**ADDENDUM NO. 5
IRONDALE PUBLIC LIBRARY**

CITY OF IRONDALE

THIS ADDENDUM FORMS A PART OF THE CONTRACT DOCUMENTS. THE FOLLOWING CONDITIONS TAKE PRECEDENCE OVER ANY CONFLICTING CONDITIONS IN THE DRAWINGS AND SPECIFICATIONS. THE DRAWINGS AND SPECIFICATIONS ARE HEREBY AMENDED IN THE FOLLOWING PARTICULARS.

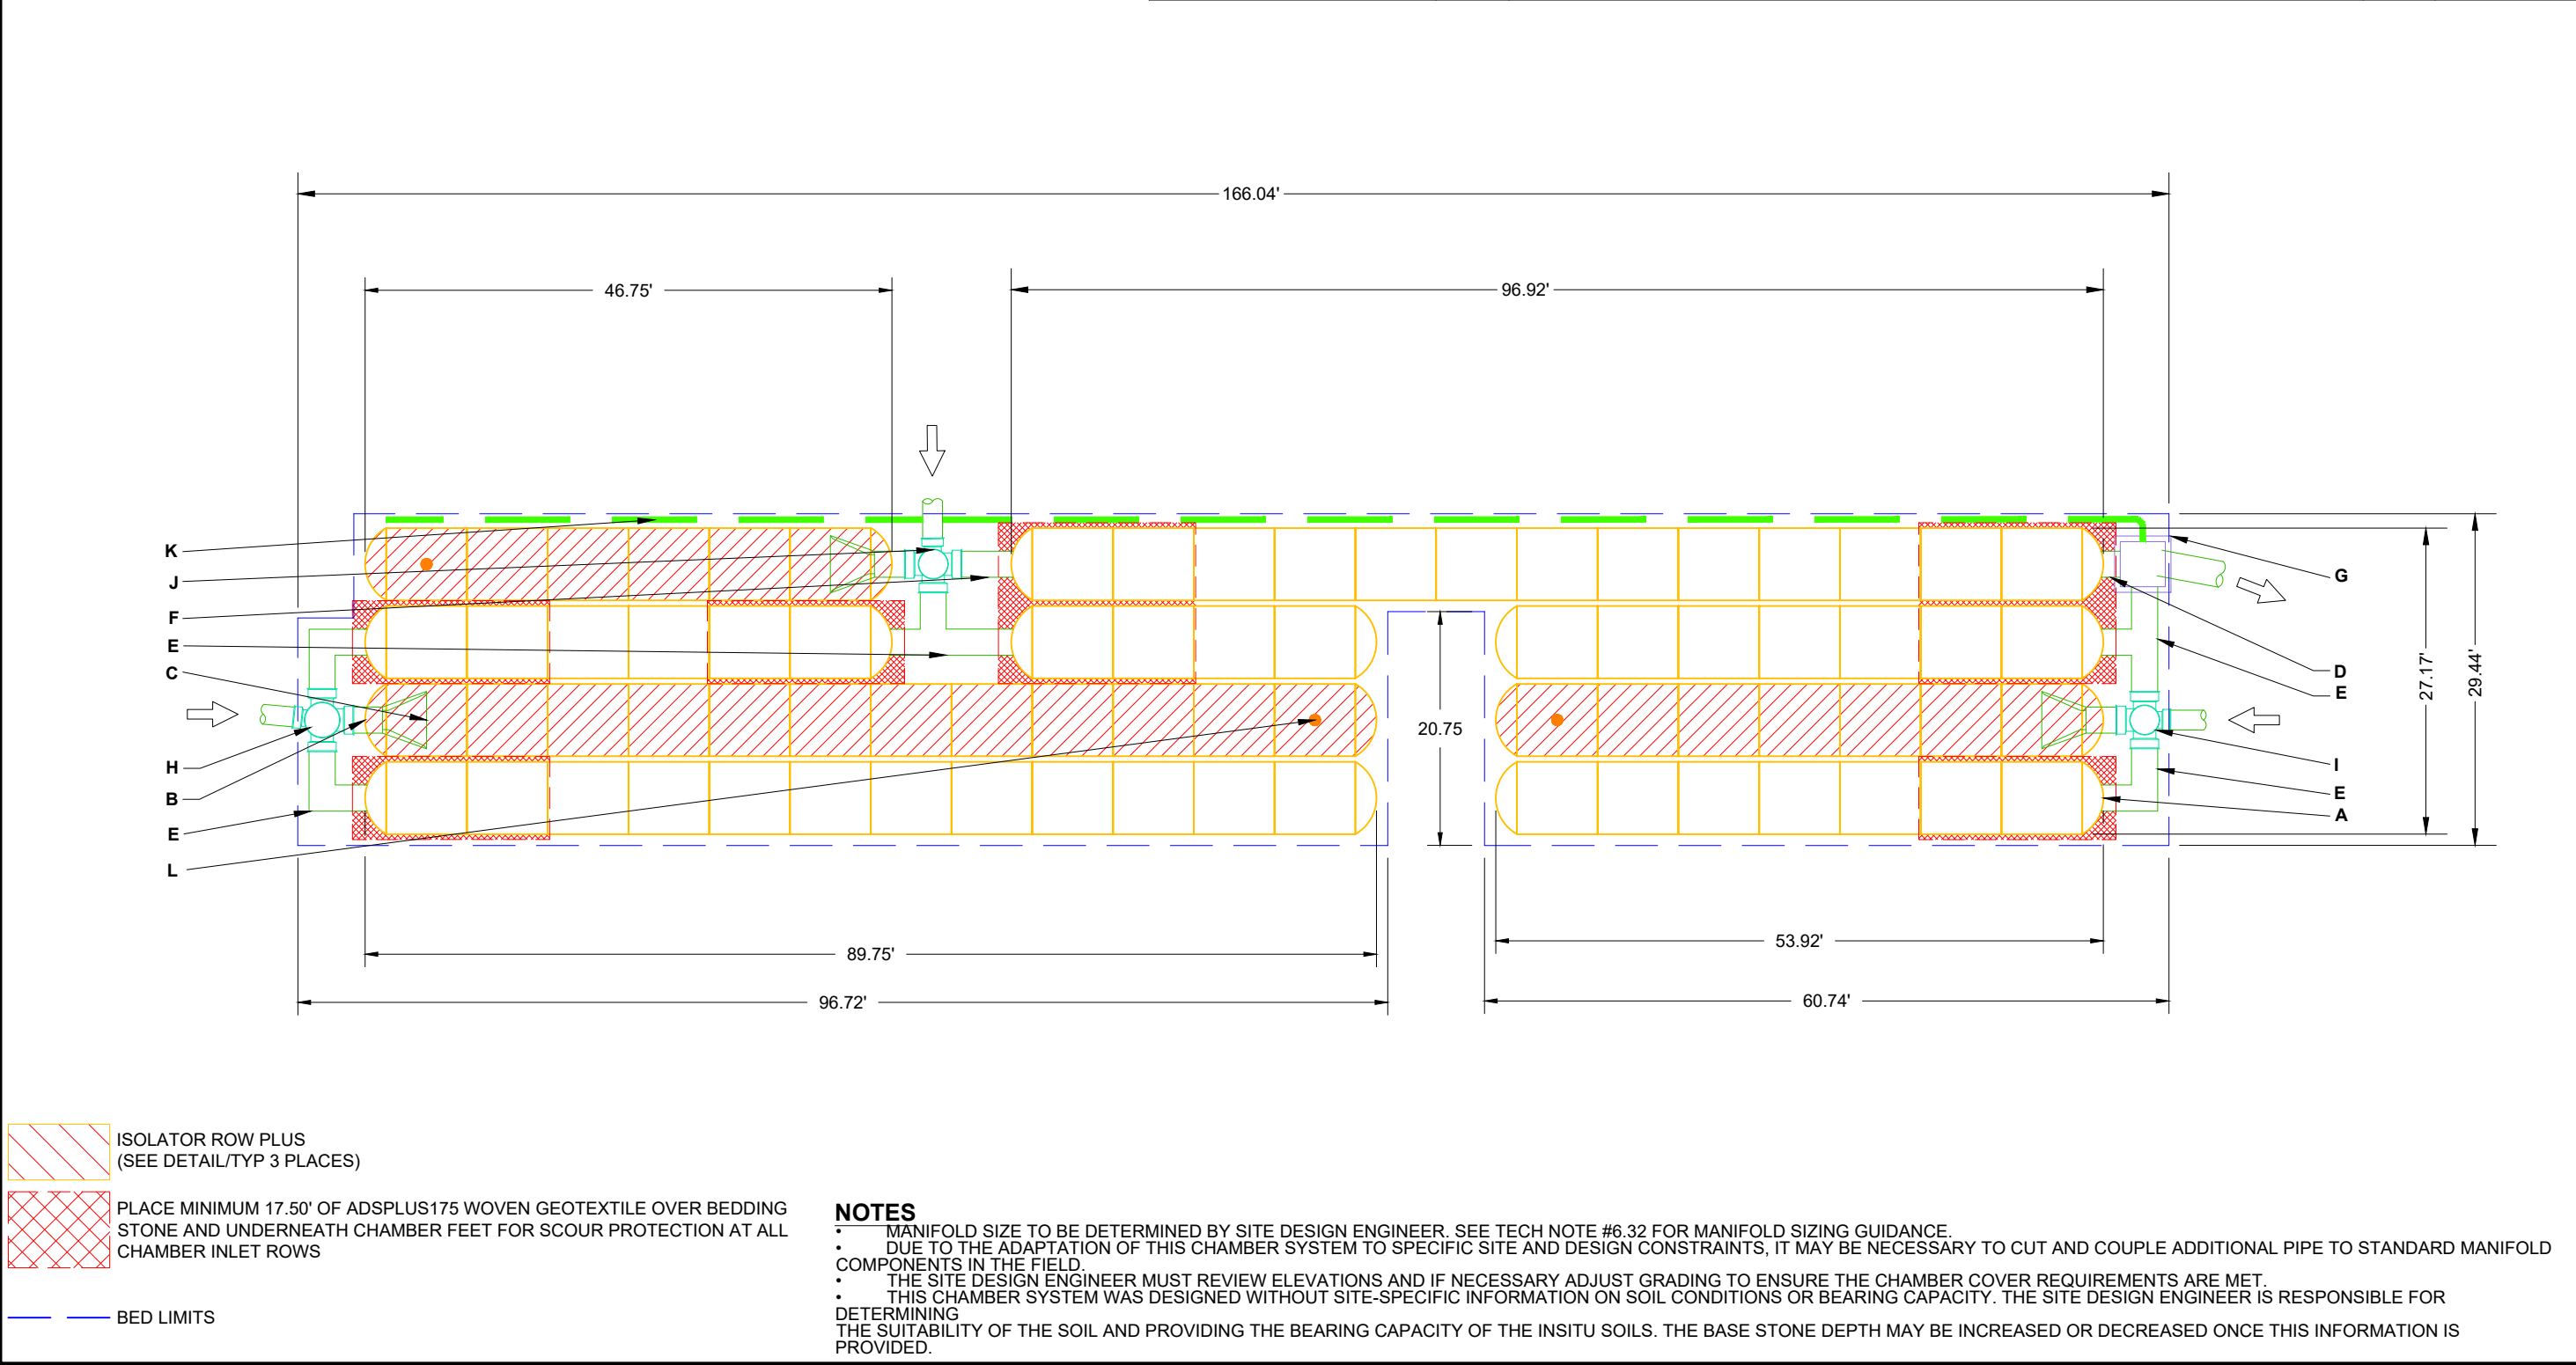
7. Please provide details for the coordination of the proposed light pole foundation that is shown to be in the underground detention system on sheet C3.01. Sheet C4.01 and C5.01 have a note pointing to a dashed box within the underground detention system that says to allow for utility pole foundation in the storm water detention chamber layout. Does this mean the underground detention will need to be left out of this boxed area to allow for the light pole foundation?

Response: The underground detention design has been coordinated with the placement of the proposed light pole base. Detention layout drawings are attached.

C1.01

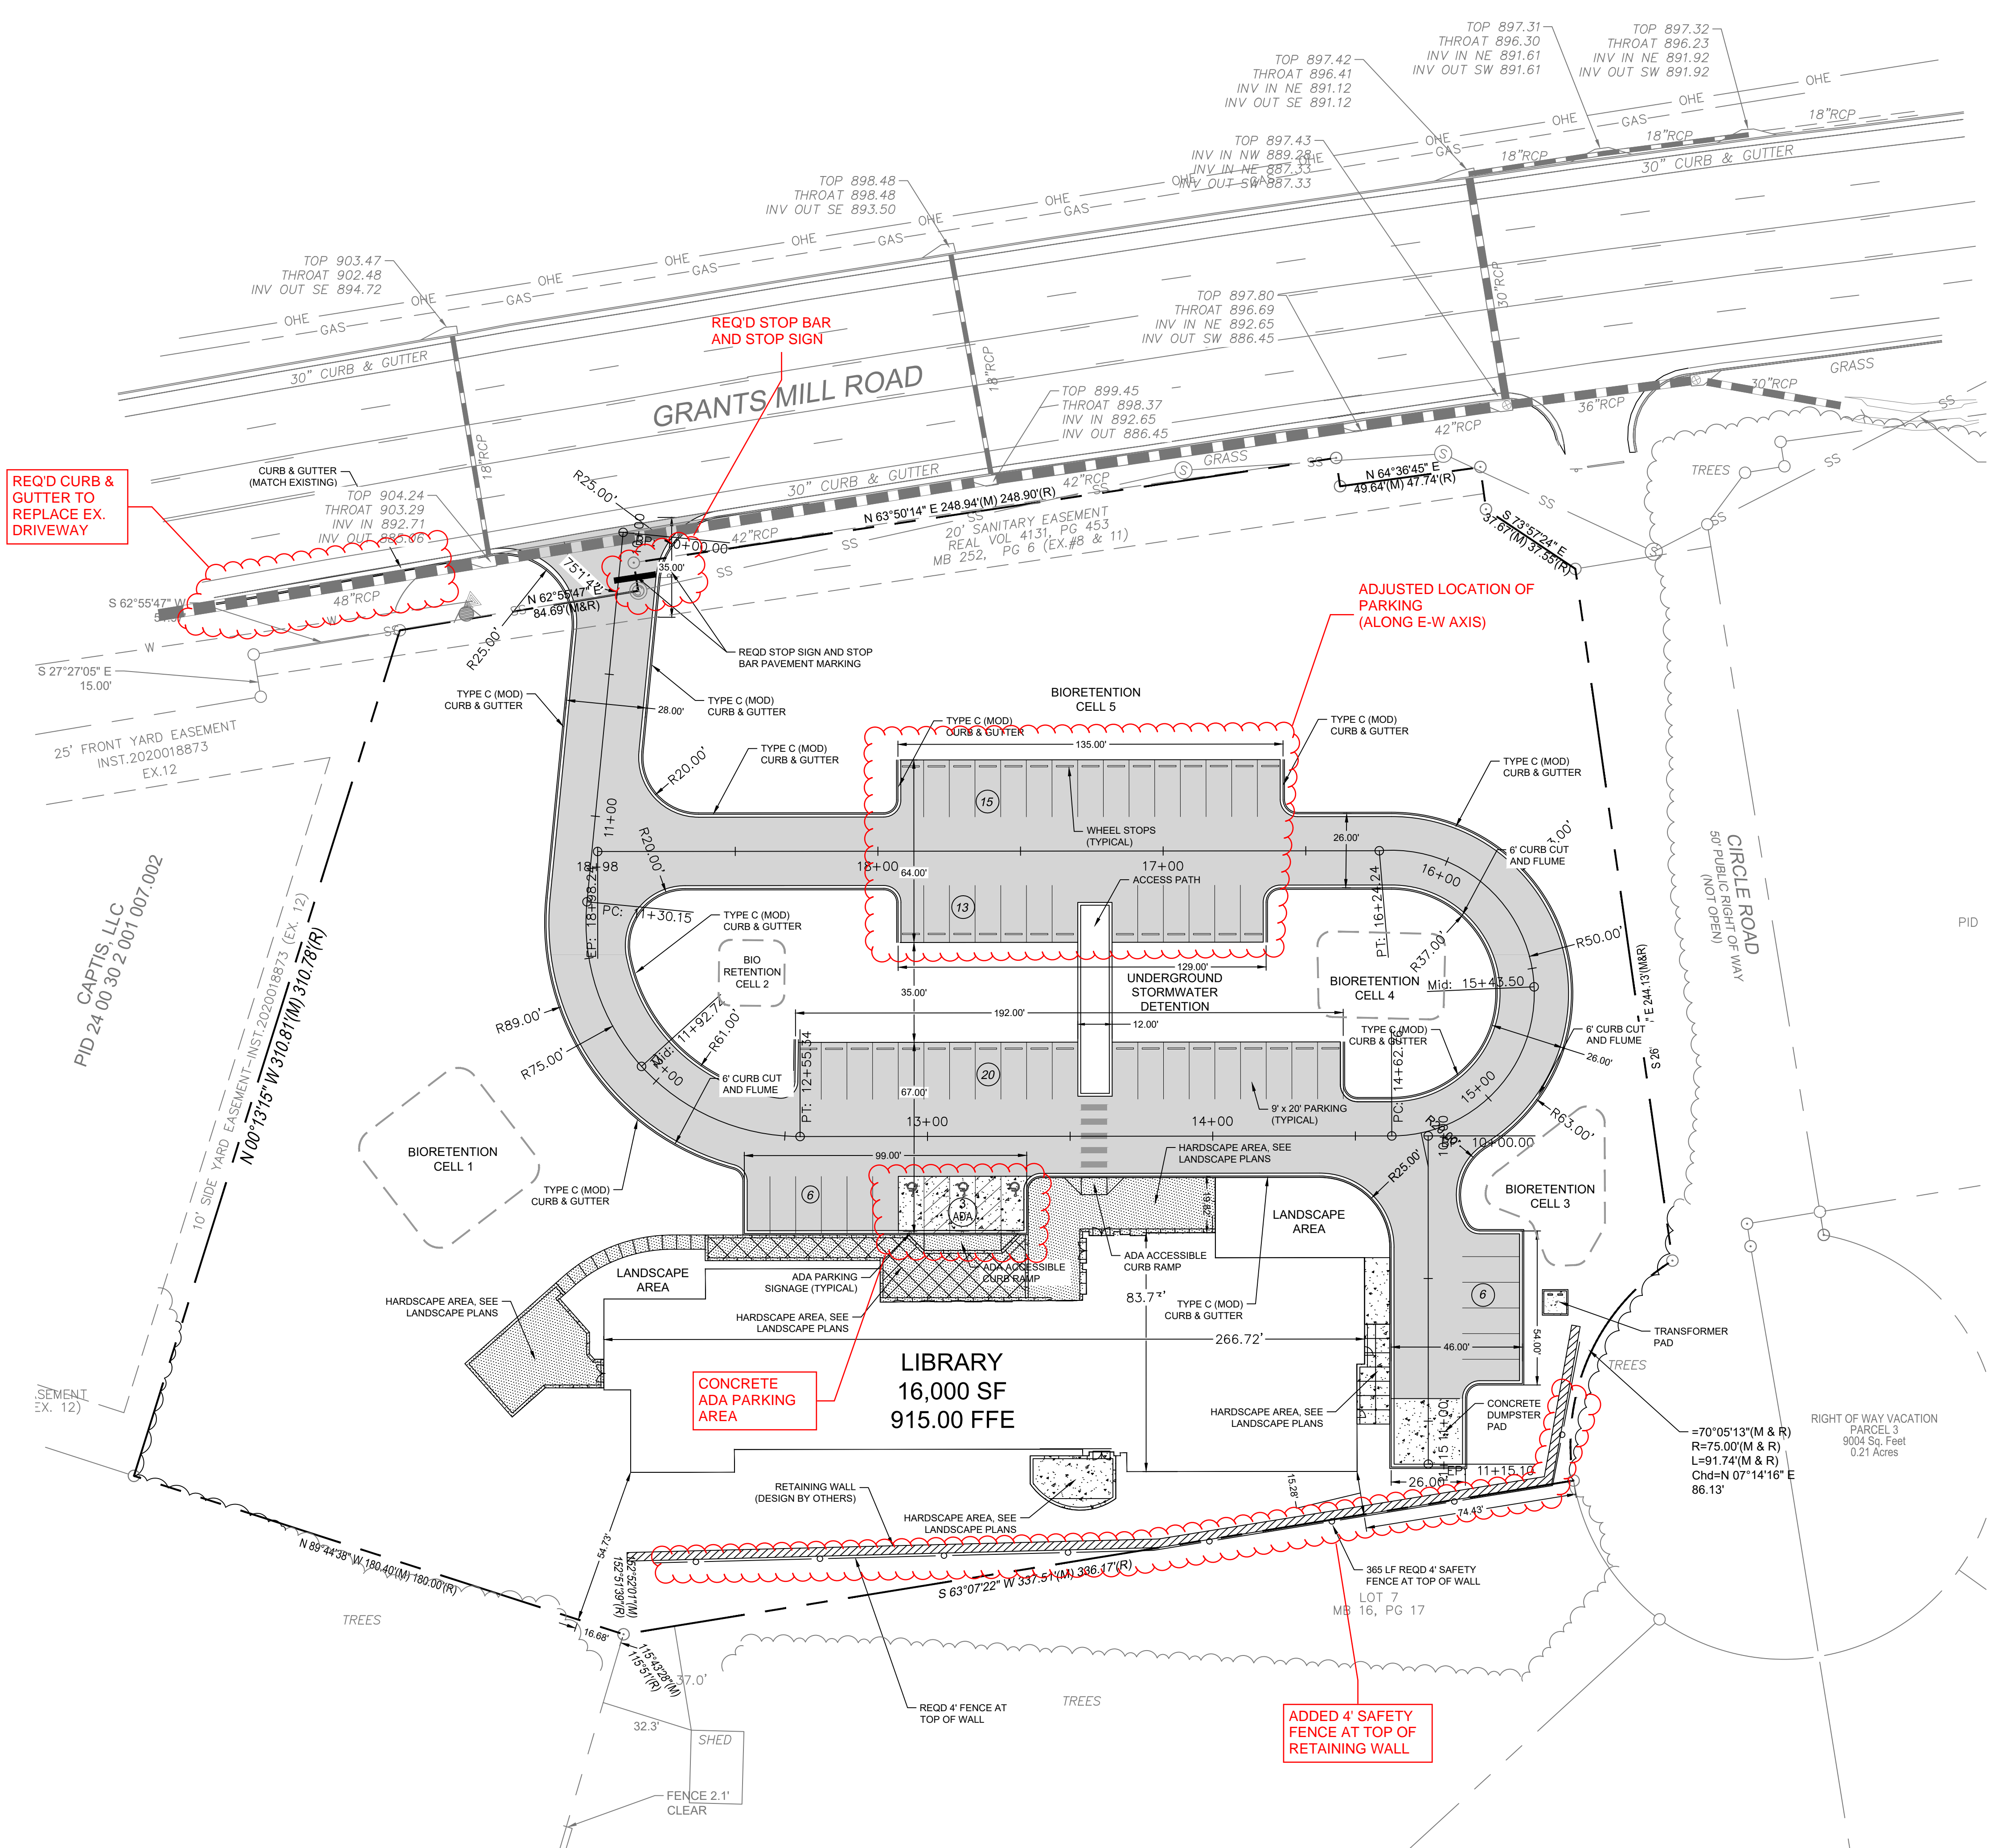
1. Sheet C1.01
 - a. Added demo and removal of existing driveway apron west of site entrance.
2. Sheet C2.01
 - a. Reprint sheet issued in Addendum 4 due to corrupted file.
